**ADDENDUM # 1**

January 22, 2018

Daniel Buchanan Elementary School HVAC Upgrades  
Murrieta Valley Unified School District  
App. # 04-115432, File # 33-32

**AC UNIT MOUNTED ON (E) SLAB**

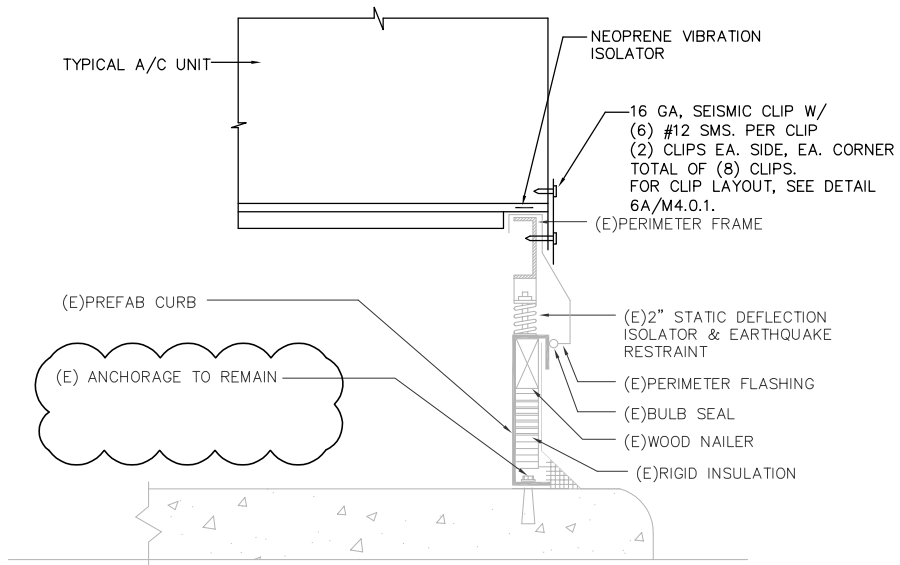
- A.** The following Addendum ("AD") Drawings are issued:
- 1.** Drawing M4.0.1: Revise currently issued drawing per AD1-M1.
  - 2.** Drawing M4.0.1: Revise currently issued drawing per AD1-M2.

**AC UNIT MOUNTED ON (E) ROOF CURB**

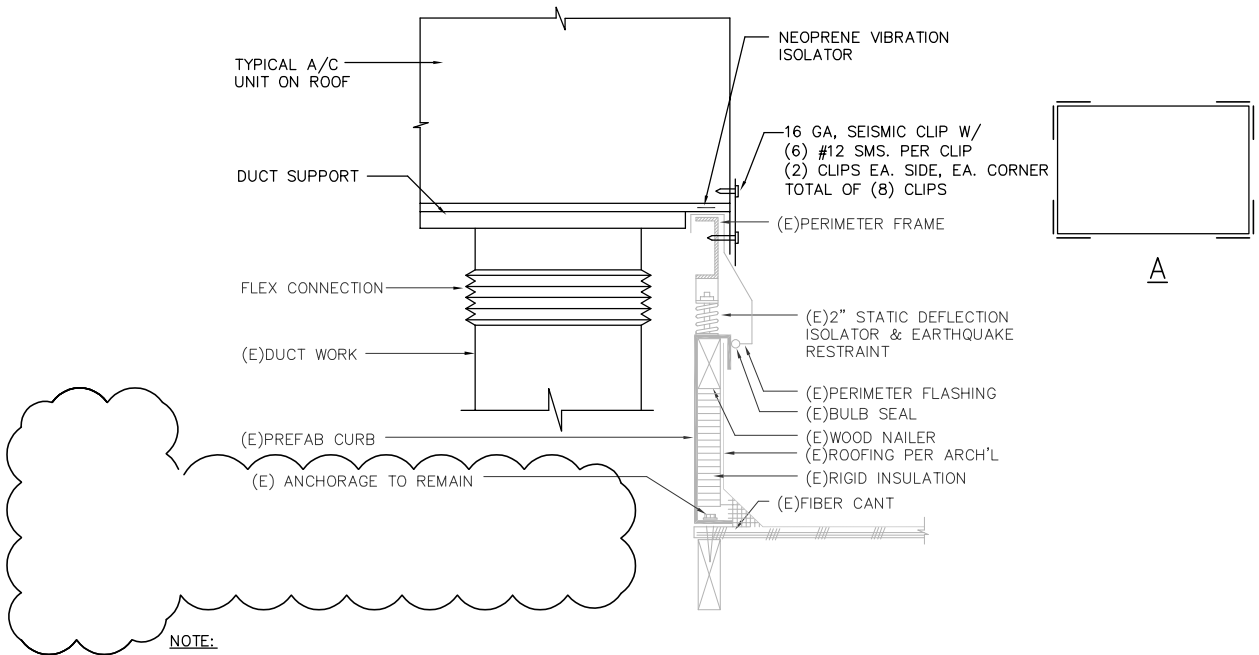
1. FILL ENTIRE VOID SPACE IN ROOF CURB WITH BATT. INSULATION.

THE FOLLOWING CHANGES WERE MADE TO DETAIL 6/M4.0.1:

- CALLOUT FOR (E) ANCHORAGE FROM (E) ROOF CURB TO (E) ROOF FRAMING WAS CHANGED TO READ: "(E) ANCHORAGE TO REMAIN".
- SKETCH SHOWING LAG SCREW PLACEMENT AROUND (E) ROOF CURB WAS REMOVED.

THE REASON BEHIND MAKING THE CHANGES WERE THAT THESE NEW UNITS BEING INSTALLED WERE LIGHTER THAN THE OLDER UNITS. AS SEEN IN THE TABLE ON THE FOLLOWING PAGE PROVIDED BY THE MECHANICAL ENGINEER FOR THIS PROJECT, ALL THE UNITS BEING PLACED AT BUCHANAN E.S. ARE LIGHTER THAN PREVIOUS UNITS. AS SUCH, THE (E) ANCHORAGE DOES NOT NEED TO BE REMOVED AND IS ADEQUATE.
